Project Waters Stage 1:

Balcony Report

Rev G
19/11/12

A MENDED IN RED **D**
24 JAN 2013
By: PEITA McCULLA # (name)
of the ULDA

6. Climate and Environment

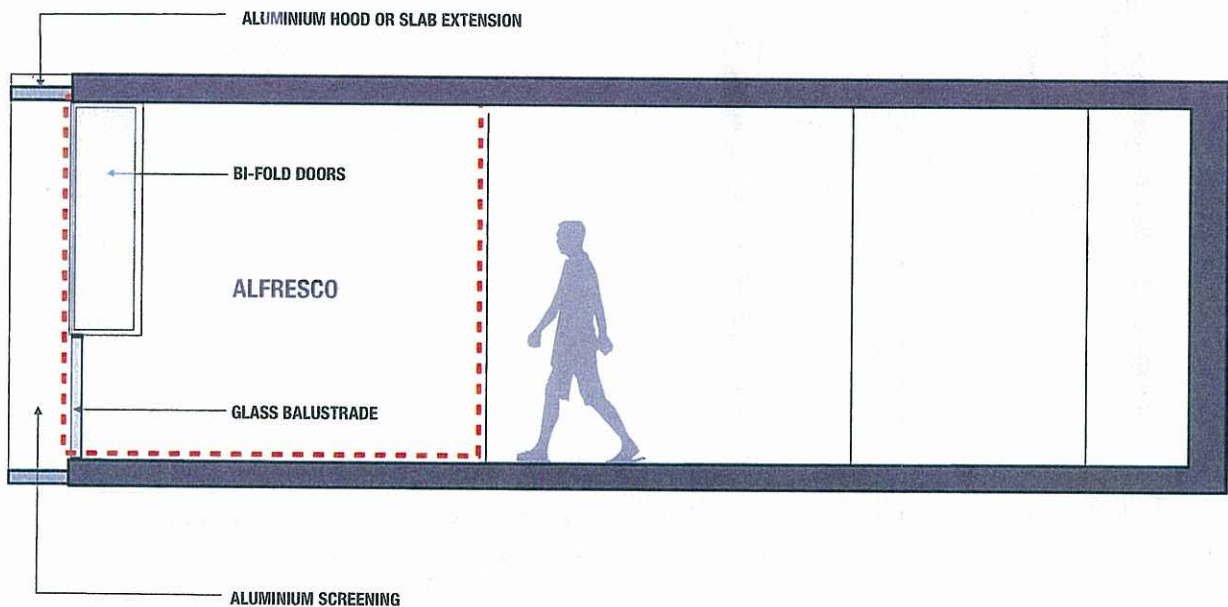
Traditionally the use of deck/balcony space around a dwelling had the effect of setting up a thermal buffer to reduce solar gain. In this scheme it is proposed to use a horizontal metal hoods or slab extensions to increase the effective depth of the adjacent 'Alfresco' space to recreate this buffer. This will be further assisted by the vertical blades and/or horizontal or vertical solid wall panels. Additionally the hoods/slab extensions will provide weather protection from the bifold edge creating a flexible balcony like zone. THE GLASS BALUSTRADE AND OR WINDOW TO INCLUDE OPENABLE PANELS. WEATHER PROTECTION REQUIRED AS PER CONDITIONS OF APPROVAL.

~~The bifold windows will also be able to be locked into position by the residents leaving a ventilation gap if so desired.~~

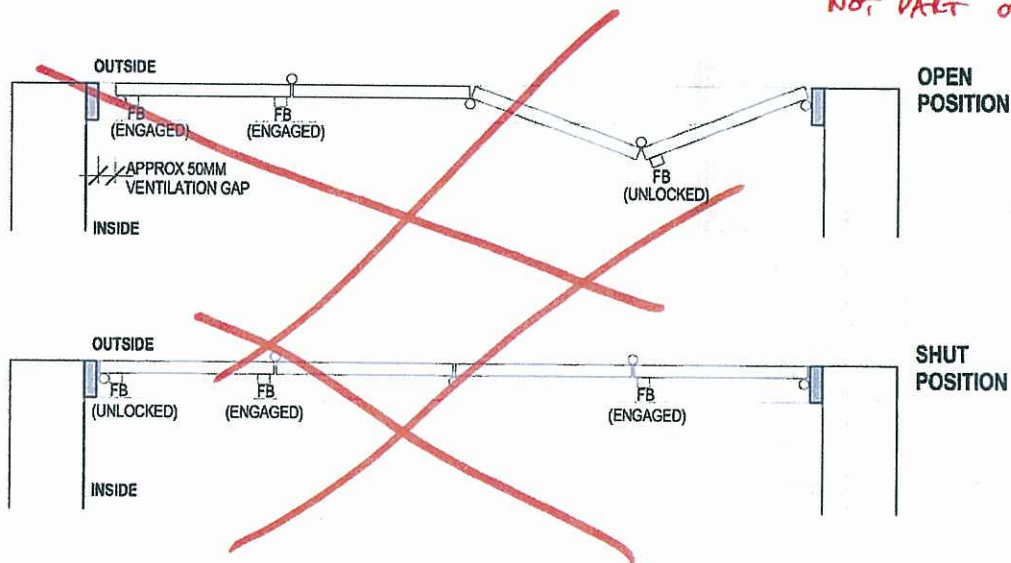
NOT PART OF THIS APPROVAL

7. Balcony Screening

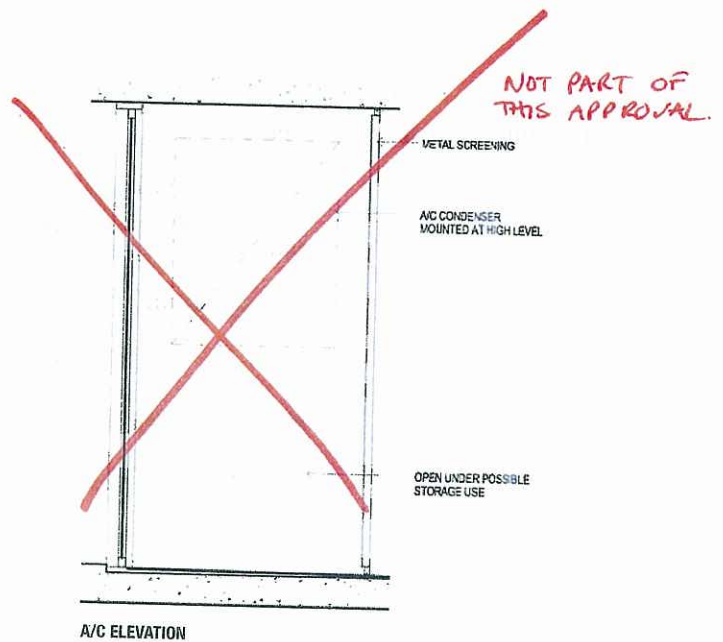
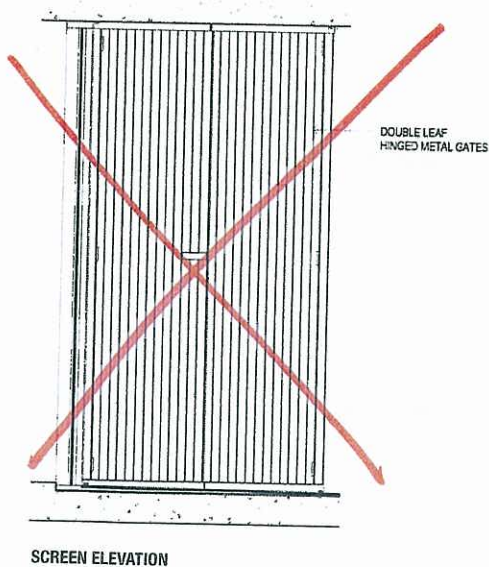
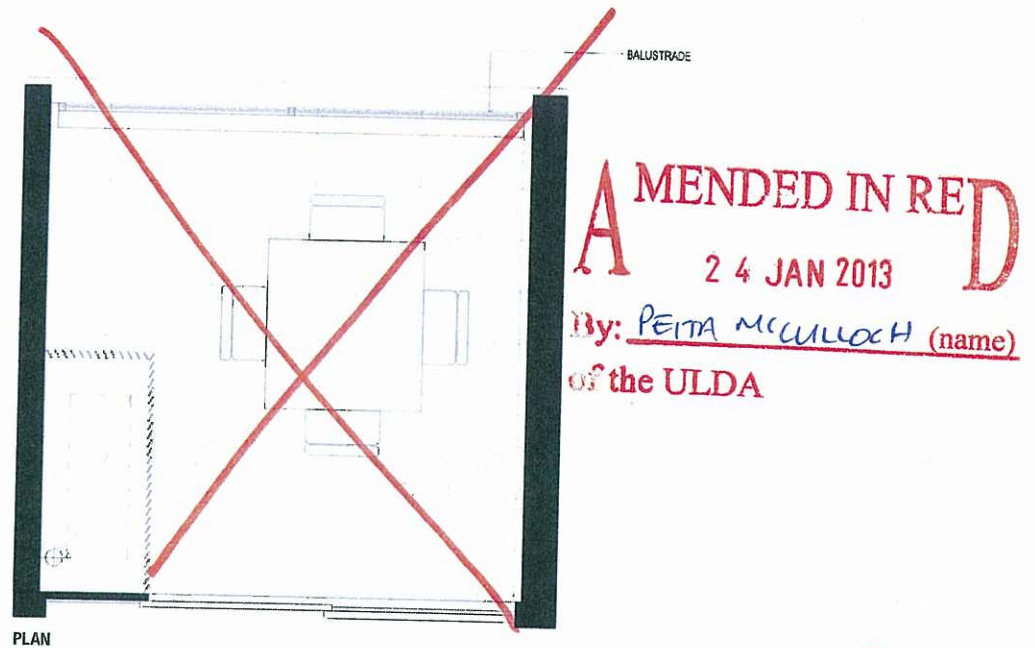
Whilst orientation and screening maximise passive climatic design, acoustic impacts and market demand also require the inclusion of air conditioning to the apartments. *Actual screening design TBA.*

~~The drawings below provide an indication of typical screening and storage arrangement for apartments with a balcony. The air conditioning enclosures provide additional storage space which is considered a significant benefit within this segment of the market.~~
